**EMERY WORLDWIDE AIRLINES**

**RESPONSE TO**

**EXHIBIT 17J**

Oct. 16<sup>th</sup> - Nov. 2<sup>nd</sup>, 2000

DAMAGE LOCATION  
FIGURE 1

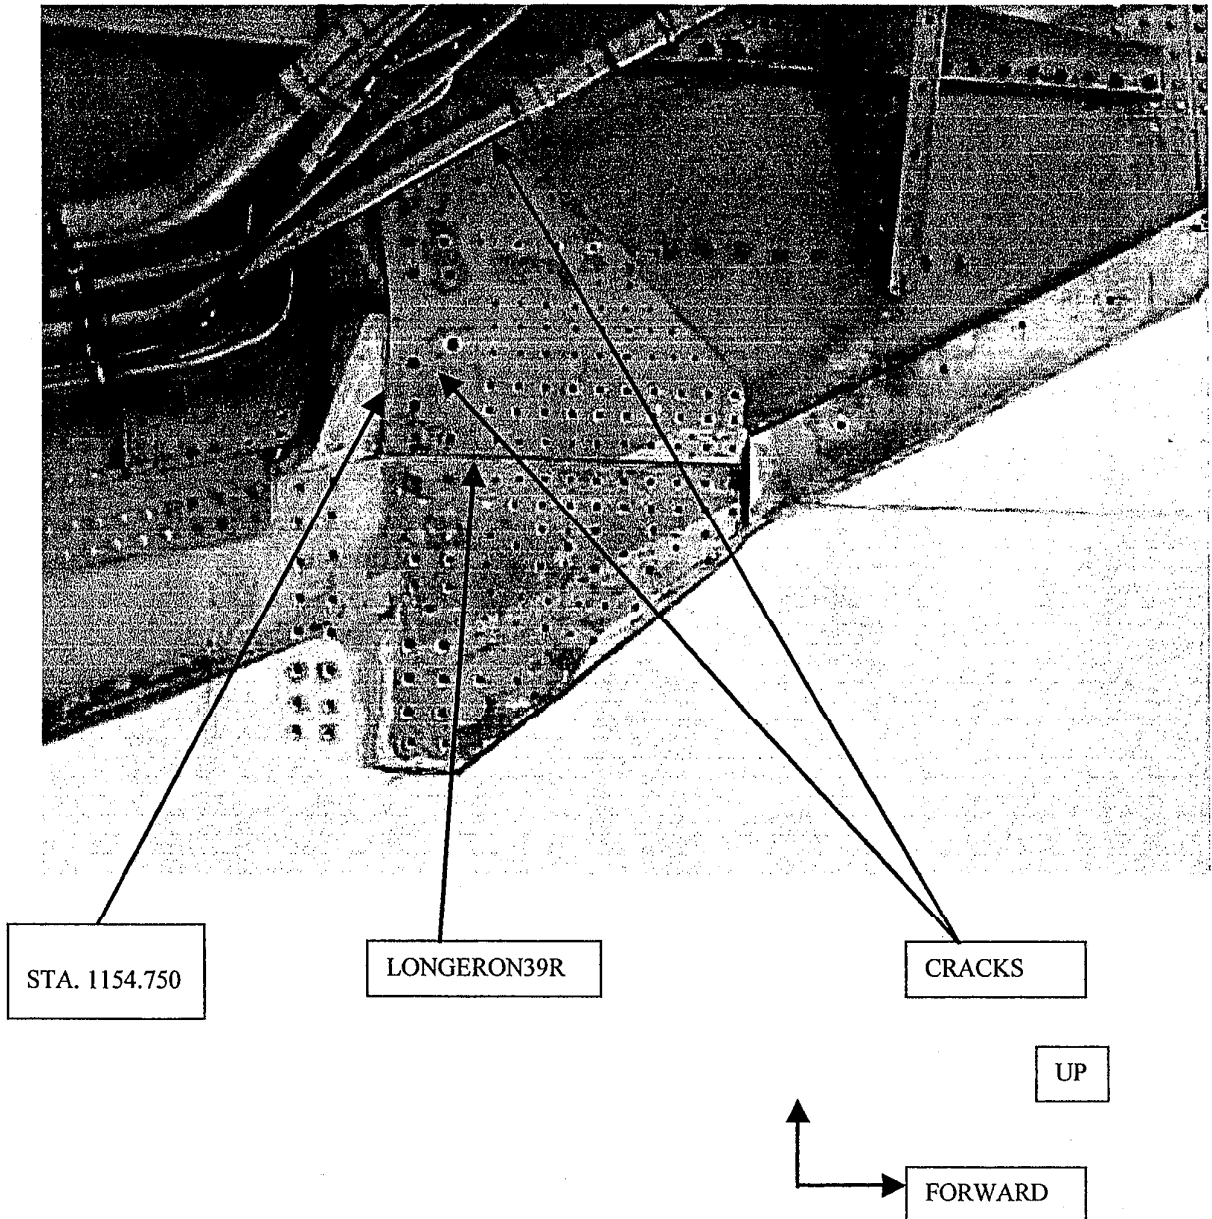
DURING HEAVY CHECK AT MAE, THE CUSTOMER REQUESTED THAT REFERENCE (B) BE INCORPORATED. THIS REQUIRED REMOVAL OF REPAIR DOUBLER THAT WAS INSTALLED BY REFERENCE (C), UNDER WHICH WAS FOUND 2 CRACKS. ONE CRACK WAS 6.1-INCHES LONG AND THE OTHER WAS 0.8-INCHES LONG BEGINNING AT AND EXTENDING FORWARD OF A FASTENER HOLE AND THE SAME CRACK WAS 0.65-INCHES LONG BEGINNING AT AND EXTENDING AFT OF SAME FASTENER HOLE. THE SKIN MATERIAL IS MADE FROM 0.090-INCH THICK CLAD 7075-T6 PER REFERENCE (A). SEE FIGURE 1 FOR DAMAGE LOCATION.

REPAIR IN ACCORDANCE WITH THE FOLLOWING STEPS. THIS REPAIR IS CONSIDERED MAJOR AND IS BOEING APPROVED PER REFERENCES (E) AND (F).

1. TRIM OUT ALL CRACKS MAINTAINING A MINIMUM OF 0.5-INCH TRIM RADIUS. BREAK ALL SHARP EDGES CREATED BY TRIM OUT.
2. PERFORM NDT EDDY CURRENT INSPECTION TO ENSURE COMPLETE CRACK REMOVAL AT TRIMMED OUT AREAS.
3. FABRICATE PER REFERENCE (D) THE SR10530073-34 DOUBLER TO PICK UP EXTRA ROWS OF FASTENERS AS SHOWN ON FIGURE 2. THE THICKNESS AND TAPER OF THE ADDED SECTIONS IS TO BE THE SAME AS WHAT THE -34 DOUBLER IS AT THE LOCAL AREA, WHERE MATERIAL WILL BE ADDED. ALSO MODIFY THE DOUBLER TO HAVE A LINEAR TAPER WHICH WILL INCREASE THICKNESS OVER TRIMMED OUT AREAS.
